**HAMMOND HIGH SCHOOL
RENOVATION AND ADDITION**

ADDENDUM NO. 2

DATE: March 6, 2020

PROJECT: Hammond High School Renovation and Addition
Columbia, Maryland
Architect Project No. 18011

AD-M01

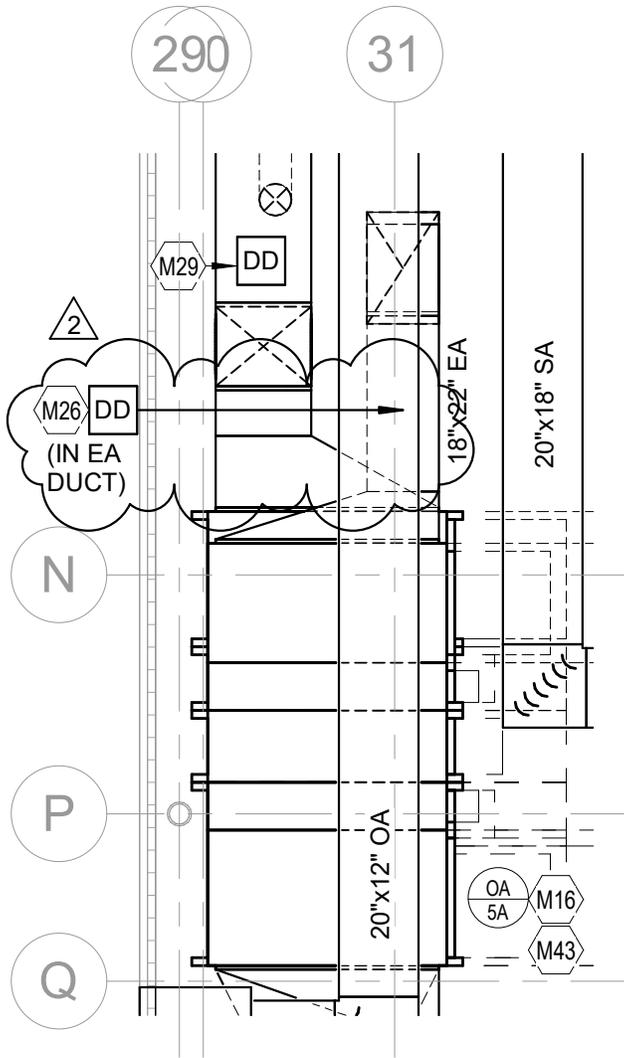
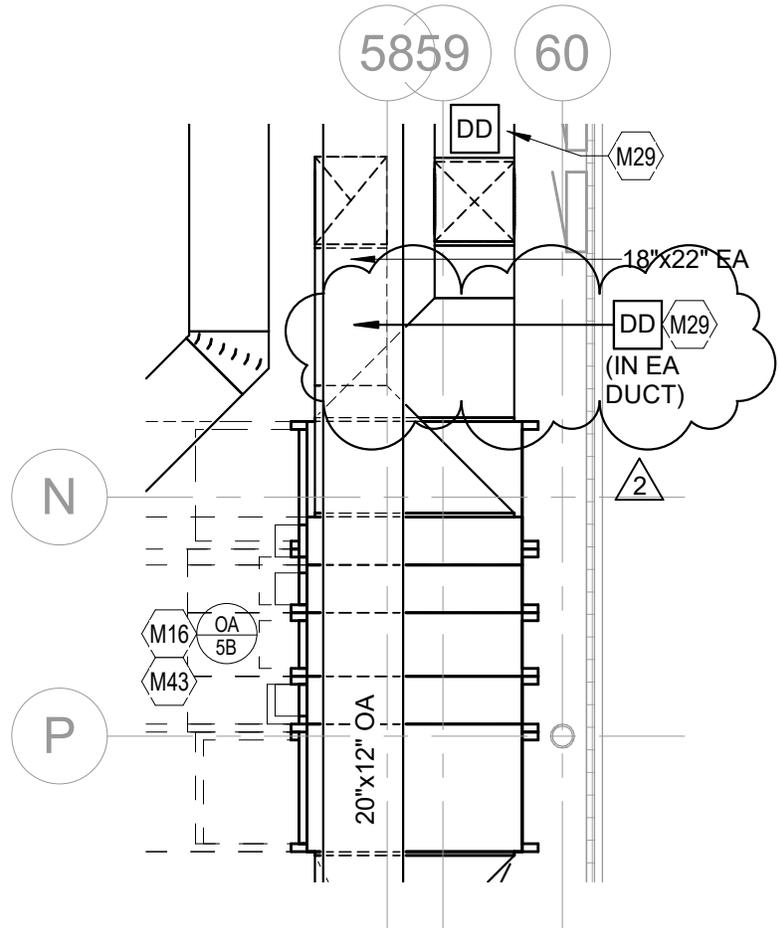
- **ADD** Emergency Boiler Shut-Off Switches. See addendum drawing AD-M01.
 - **ADD** EF-11 3-hr timer switch. See addendum drawing AD-M01.
- Sheet M4.06 – ENLARGED PLANS – MECHANICAL

SMOLEN • EMR • ILKOVITCH ARCHITECTS	HAMMOND HIGH SCHOOL RENOVATION AND ADDITION	REF SHT NO.: M4.06
		SCALE: 1/4" = 1'-0"
9211 CORPORATE BLVD. SUITE 340 ROCKVILLE, MD 20850 301-770-0177(P) 301-330-3224(F)	ITEM: DUCT MOUNTED SMOKE DETECTORS - OA-5A, 5B	ADDENDUM: 02
		DATE: 03/06/20
		AD-M02

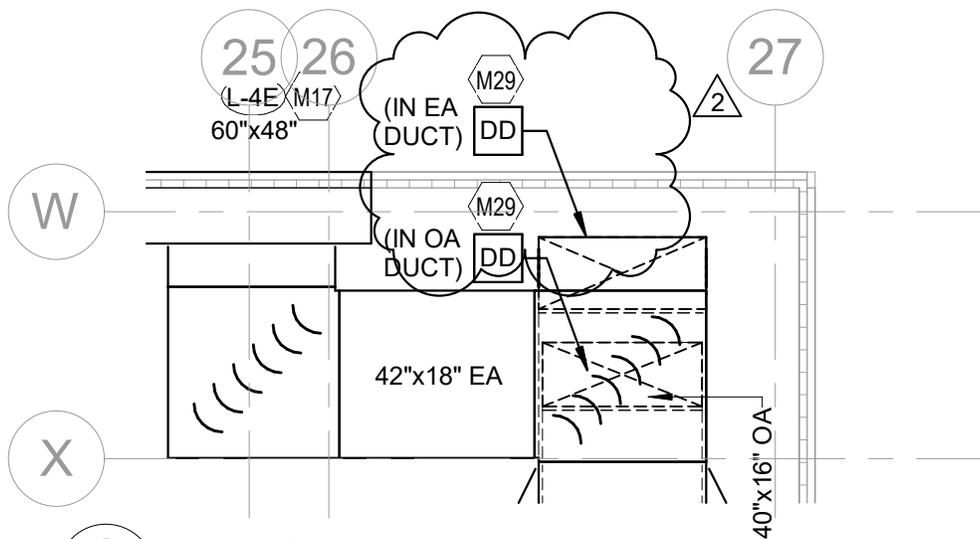
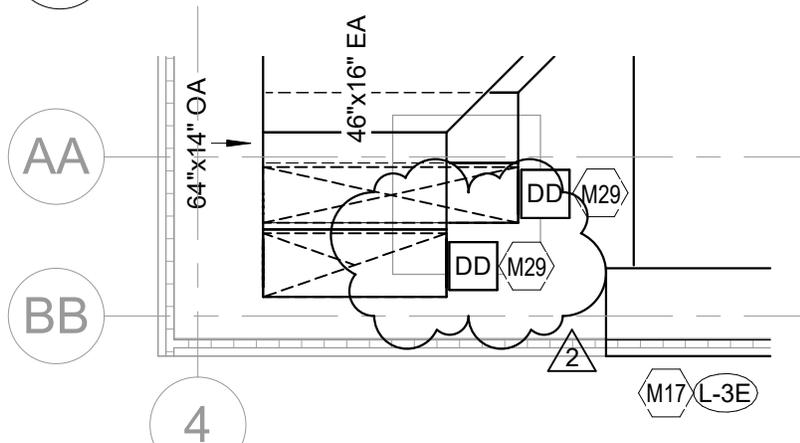
- **ADD** Duct-Mounted Smoke Detectors. See addendum drawing AD-M02.
- Sheet M4.07 – ENLARGED PLANS – MECHANICAL
 - **ADD** Duct-Mounted Smoke Detectors. See addendum drawing AD-M03.

REF SHT NO.: M4.08
 SCALE: 1/4" = 1'-0"
 ADDENDUM: 02
 DATE: 03/06/20

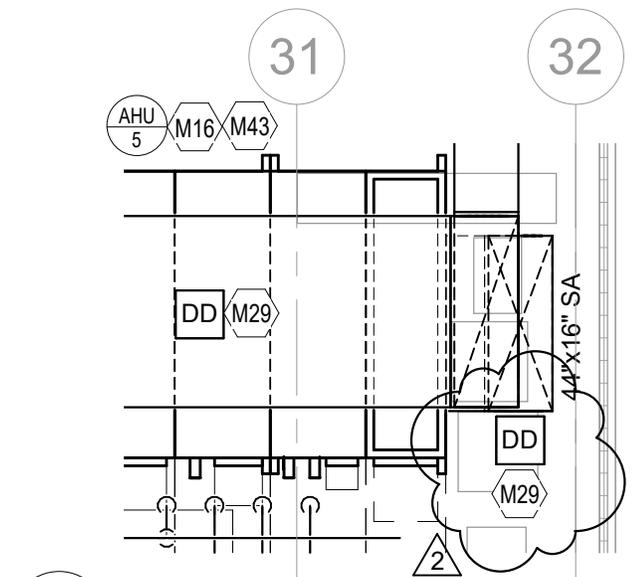
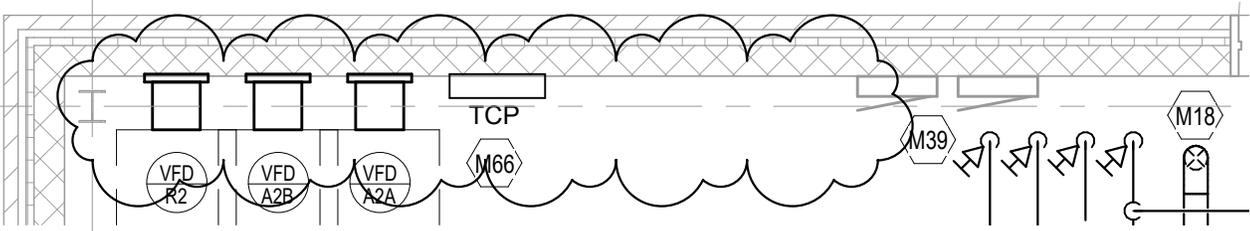
- Sheet M4.08 – ENLARGED PLANS – MECHANICAL
 - **ADD** Duct-Mounted Smoke Detector. See addendum drawing AD-M04.
 - **ADD** VFD-R3 to ENLARGED PENTHOUSE #6 – MECHANICAL. See addendum drawing AD-M04.

- **REVISE** TCP location in ENLARGED PENTHOUSE #6 – MECHANICAL. See addendum drawing AD-M04.
 - **ADD** TCP to ENLARGED AUDITORIUM MECHANICAL ROOM #1 – MECHANICAL. See addendum drawing AD-M04.

1 ENLARGED PENTHOUSE #7 - MECHANICAL
 M4.09 SCALE: 1/4" = 1'-0"

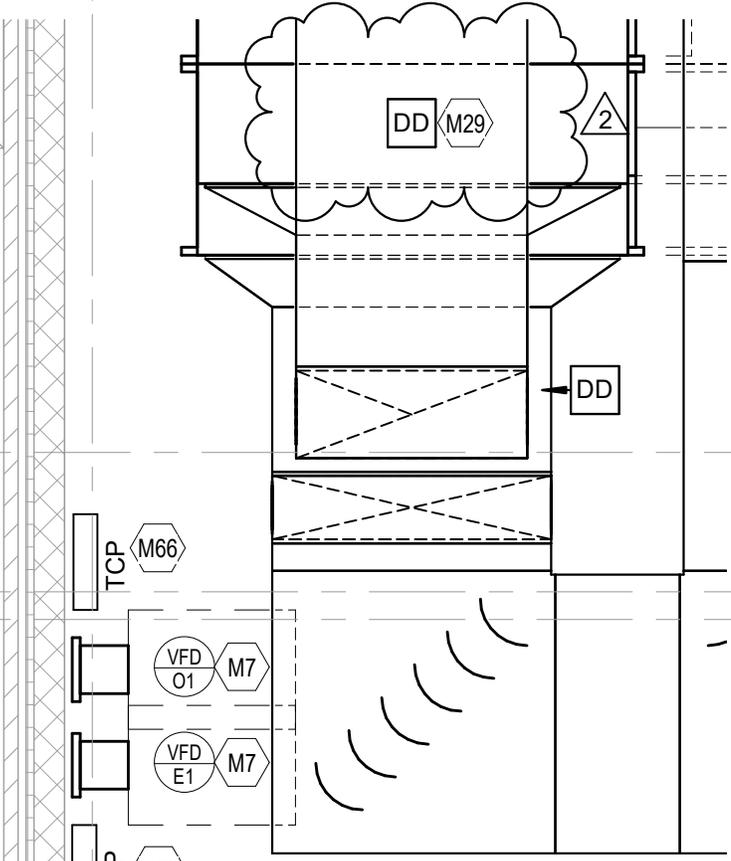
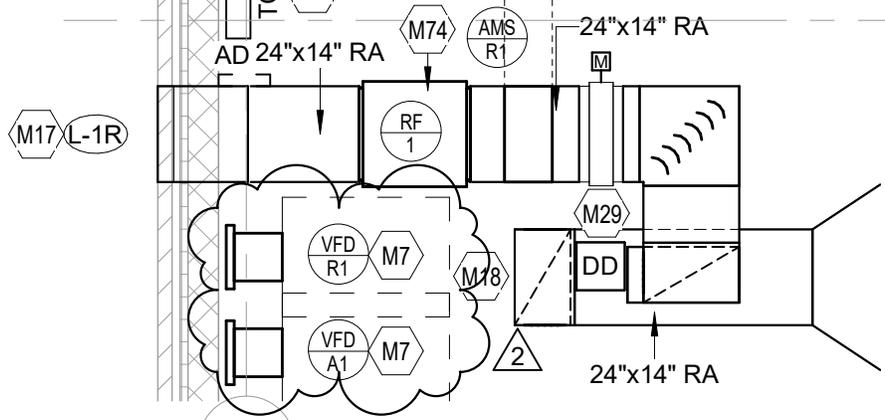
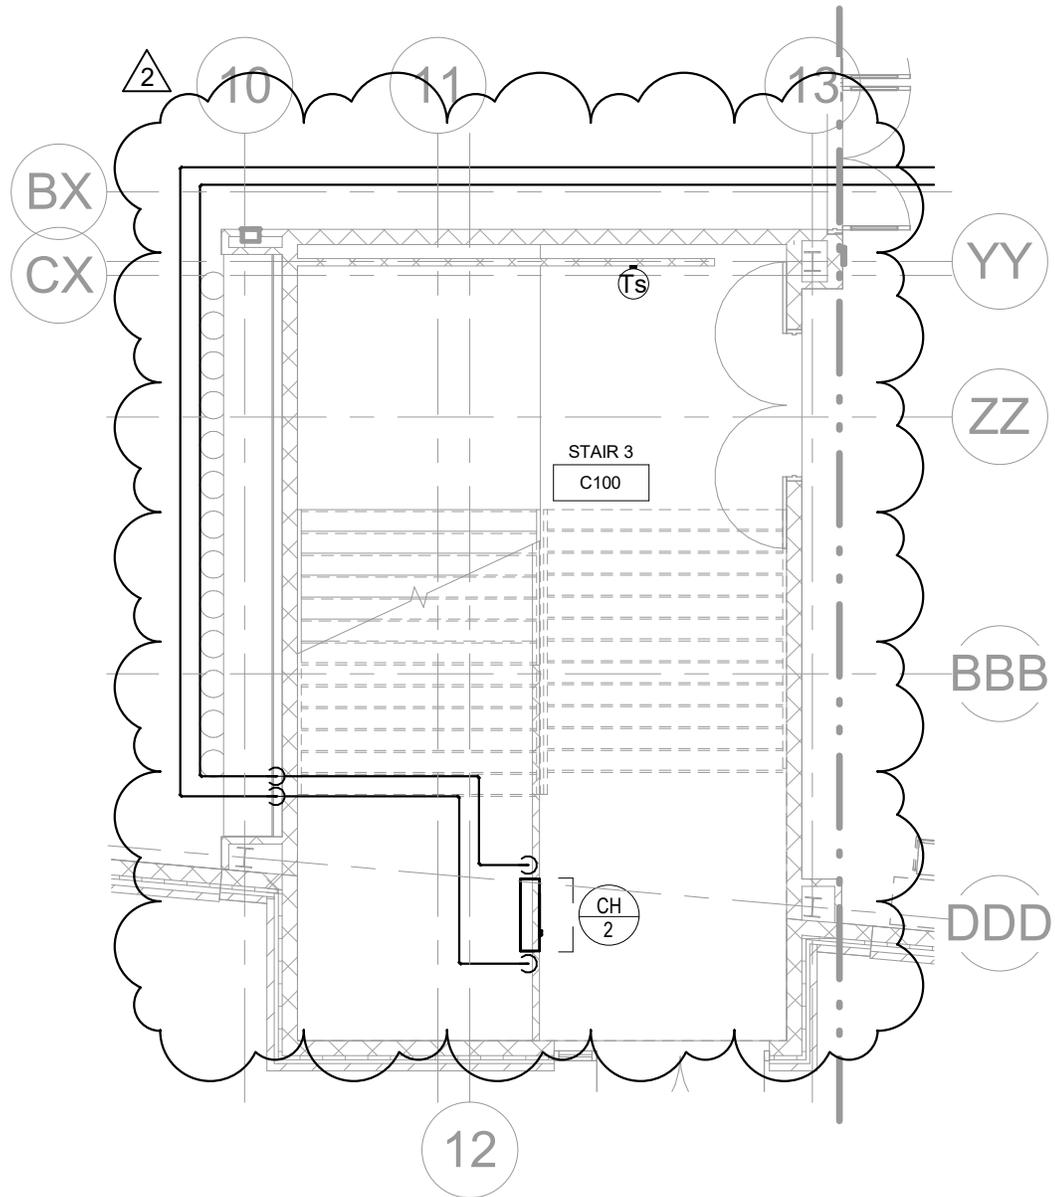
- Sheet M4.09 – ENLARGED PLANS – MECHANICAL
 - **ADD** Duct-Mounted Smoke Detectors. See addendum drawing AD-M05.
 - **REVISE** VFD-A1, R1 locations in ENLARGED PENTHOUSE #7 – MECHANICAL. See addendum drawing AD-M05.

- **REVISE** VFD-R2, A2B, A2A, and AHU-2 TCP locations in ENLARGED PENTHOUSE #7 – MECHANICAL. See addendum drawing AD-M05.
- Sheet M5.02 – MECHANICAL PIPING SCHEMATICS

ITEM:
 CABINET HEATER - STAIR 3 C100

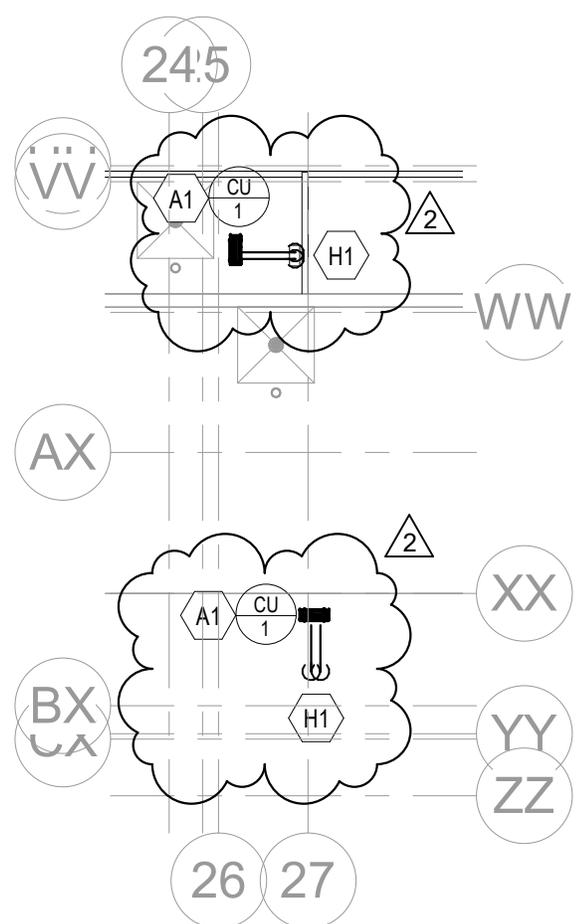
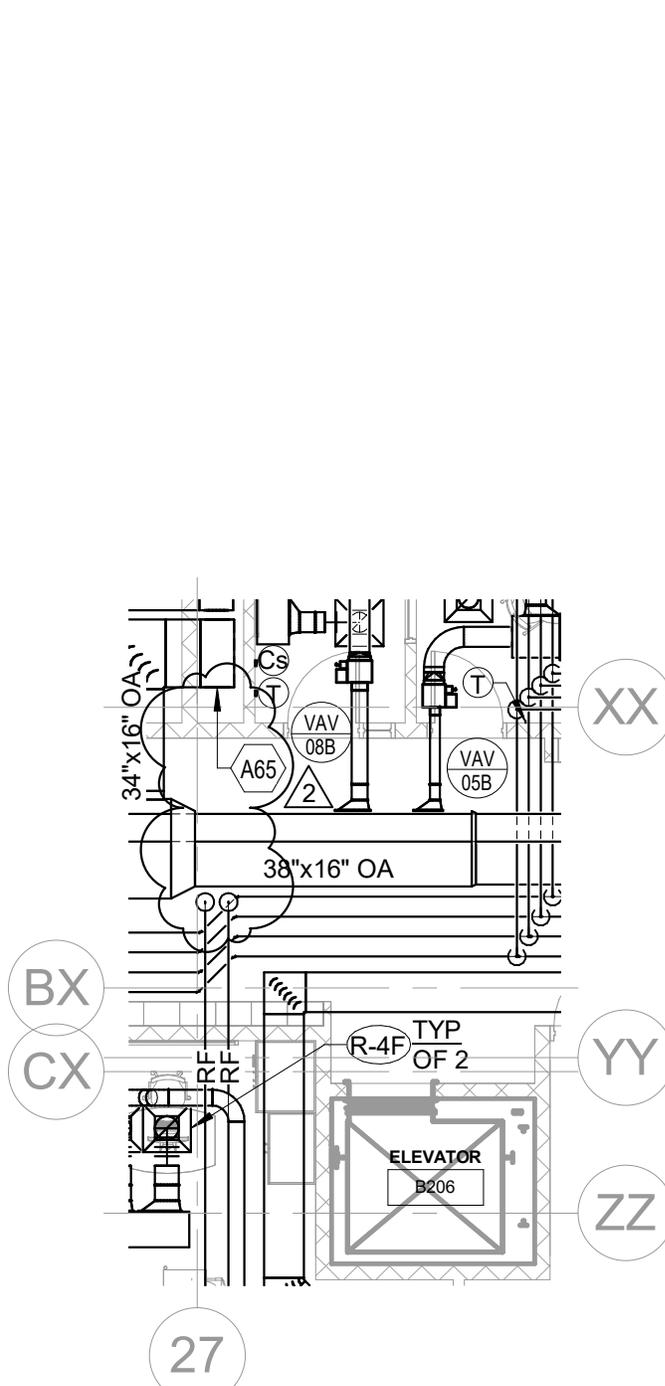
- **REVISE** diffuser type in CAFETERIA COMMONS B112. See addendum drawing AD-M10.
- Sheet M3.03 – FIRST FLOOR PLAN – AREA C – MECHANICAL
 - **REVISE** CH-2 location. See addendum drawing AD-M06.

M3.20
 REF SHT NO.: M3.10
 SCALE: As indicated
 ADDENDUM: 02
 DATE: 03/06/20

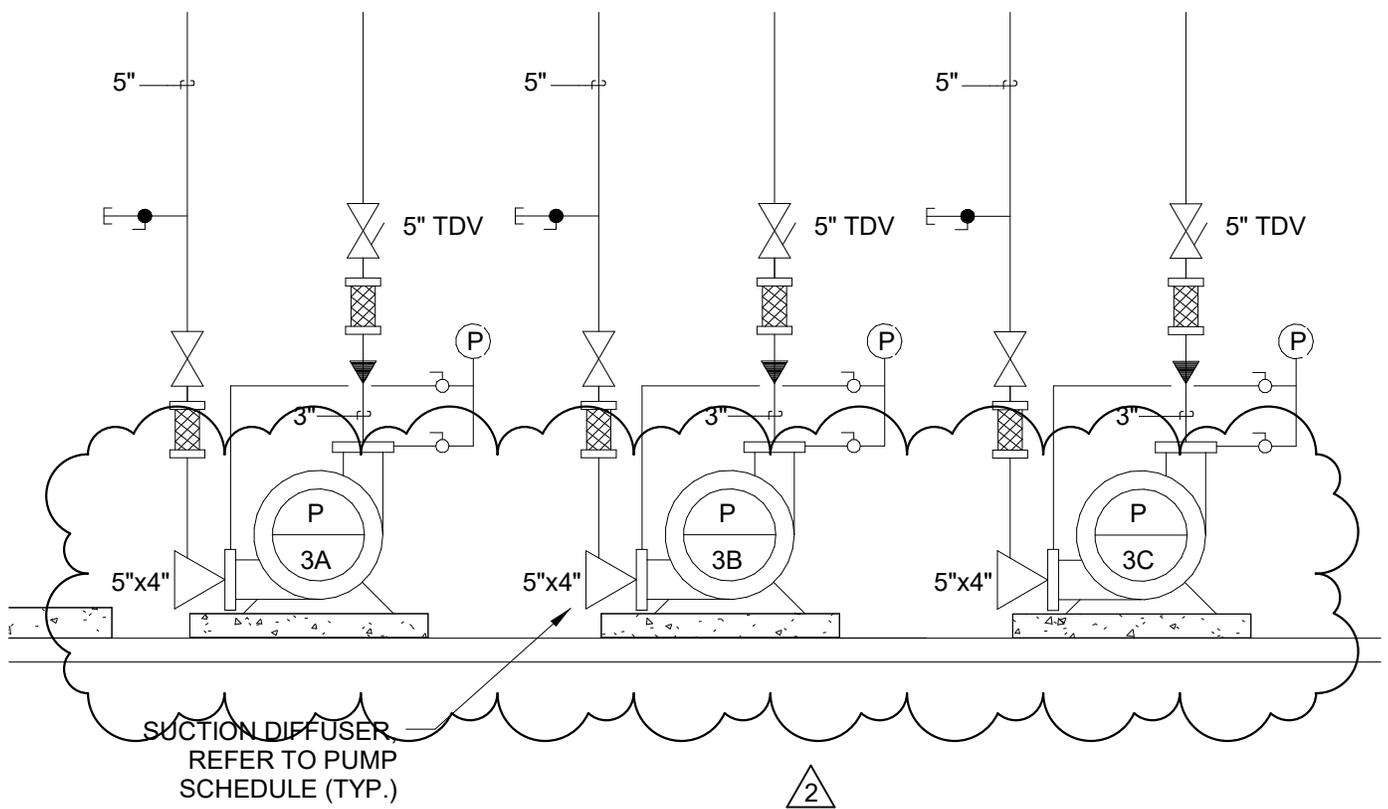
- **REVISE** R-1 airflow in P1 H105A. R-1 shall be balanced to 75 CFM in lieu of 100 CFM.
- Sheet M3.10 – SECOND FLOOR PLAN – AREA B & C – MECHANICAL
 - **REVISE** IDF B210 AC-1 refrigerant pipe route. See addendum drawing AD-M07.

- Sheet M3.20 – OVERALL ROOF PLAN – MECHANICAL
 - **REVISE** IDF B210 CU-1 location. See addendum drawing AD-M07.
- Sheet M4.02 – ENLARGED BOILER ROOM PLAN – MECHANICAL

REF SHT NO.: M3.01

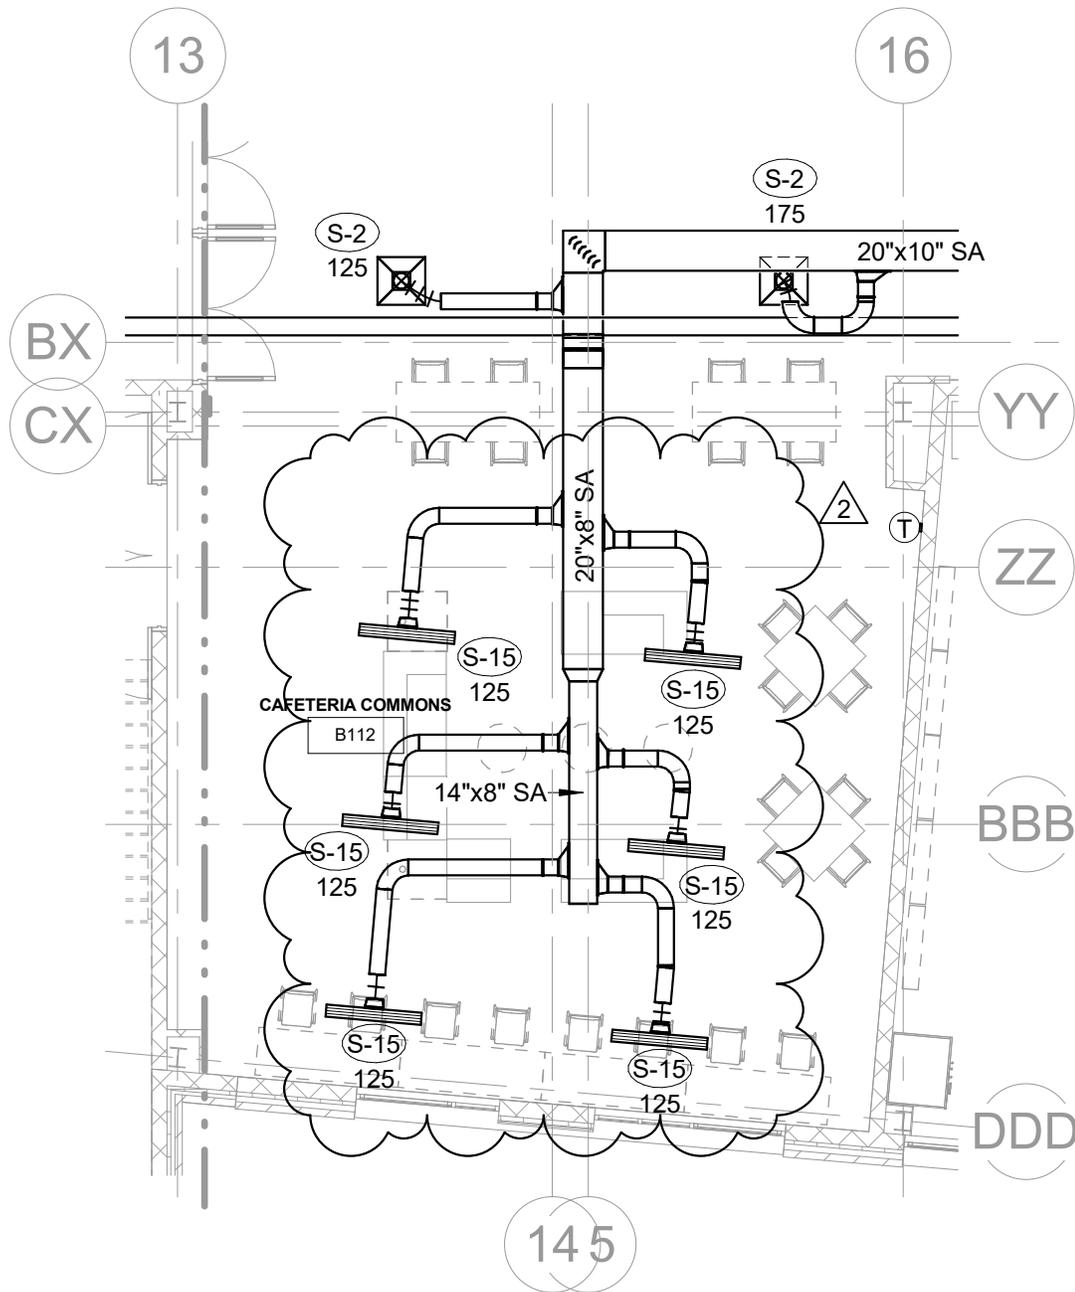
- Sheet M3.01 – FIRST FLOOR PLAN – AREA A – MECHANICAL
 - **REVISE** diffuser type in LOBBY A102. See addendum drawing AD-M09.
- Sheet M3.02 – FIRST FLOOR PLAN – AREA B – MECHANICAL
